Product Service Bulletin: *Flip Cushion Retaining Ring*

Some Flip Cushions (Seats Part Number 188599) may have Retaining Rings that are missing or not fully seated on the bar. Below are instructions on how to identify this condition followed by instructions for correcting the issue.

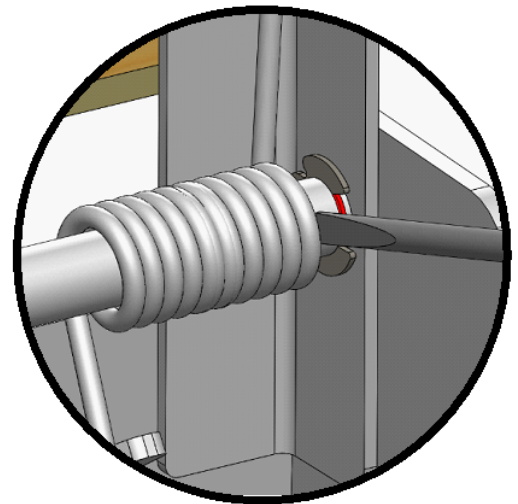
Correct Condition: Retaining Ring is present and freely rotates on shaft.

Incorrect Condition: Retaining Ring is missing or is present and does not freely rotate on shaft.

To verify if the Retaining Ring rotates freely on the shaft, the pressure from the spring on the Retaining Ring has to be relieved. Wedging a flat-headed screwdriver between the spring and the side of the seat is a good way to go about this. With one hand relieving spring pressure, try to rotate the Retaining Ring with the other hand.

If your Retaining Ring is not fully seated, simply push it the rest of way on until it is fully seated. This can easily be done with any hard, flat tool. (*Examples: Needle-nose pliers, flat-headed screwdriver, etc.*) If your Retaining Ring is missing, ensure that the pivot rod slot is between the spring and the side of the seat by sliding the pivot rod as needed. Retrieve your new Retaining Ring and place it in the pivot rod slot nearest the spring as shown in above images.
